# CITY OF ALBUQUERQUE

**RE: 3110 San Isidro St. NW**  
**Grading and Drainage Plan**  
**Engineer's Stamp Date: 05/20/20**  
**Hydrology File: G13D038**

ENGINEER'S SEAL	<b>LOT 42-B LIVINGTON PLACE</b> <b>SAN ISIDRO ST N.W.</b>	DRAWN BY DEM
		DATE 5-20-20
5/20/20	<b>GRADING AND DRAINAGE PLAN</b>	LOT 42B LIVINGTON PLACE.DWG
DAVID SOULE P.E. #14522	 <i>Rio Grande</i> <i>Engineering</i> 1606 CENTRAL AVENUE SE SUITE 201 ALBUQUERQUE, NM 87106 (505) 872-0899	SHEET #  <b>C1</b>
		JOB #  _____

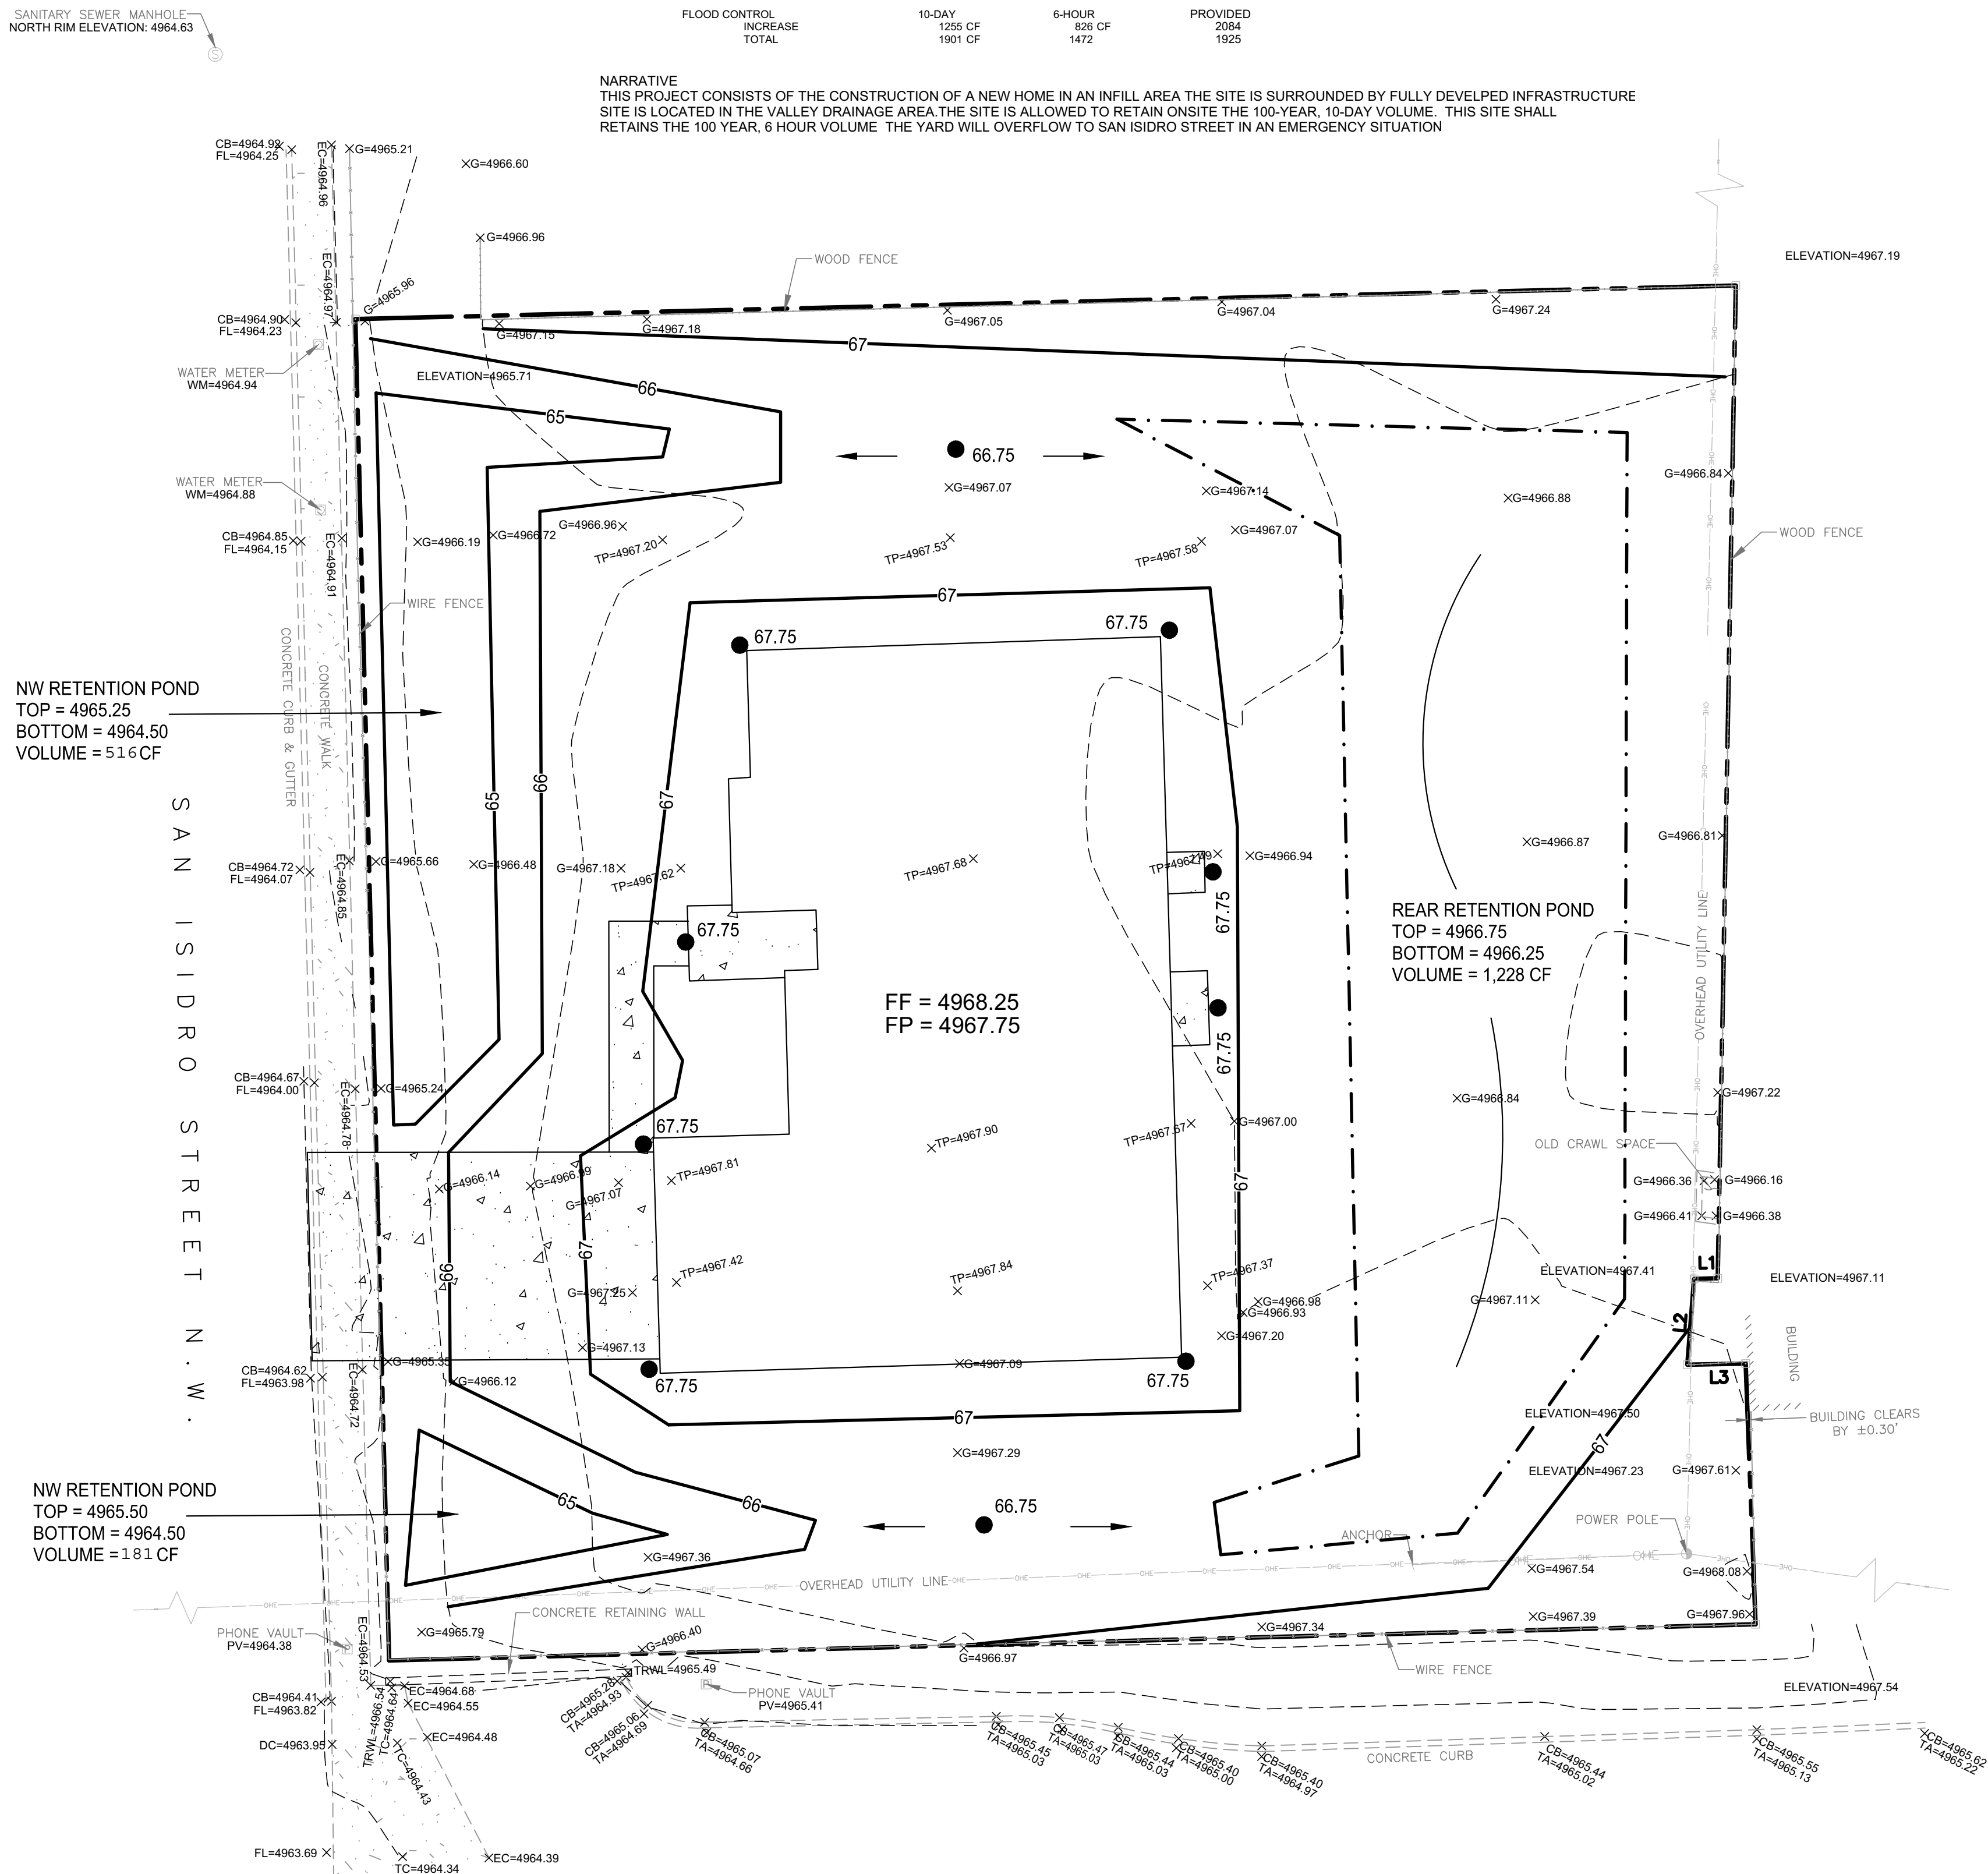
Based upon the information provided in your submittal received 05/27/20, the Grading and Drainage Plan is approved for Building Permit.

Once the grading is complete, a pad certification will be required prior to release of Building Permit. Please attach a copy of this approved plan in the construction sets for Building Permit processing along with a copy of this letter and the pad certification approval letter.

Prior to approval in support of Permanent Release of Occupancy by Hydrology, Engineer Certification per the DPM checklist will be required.
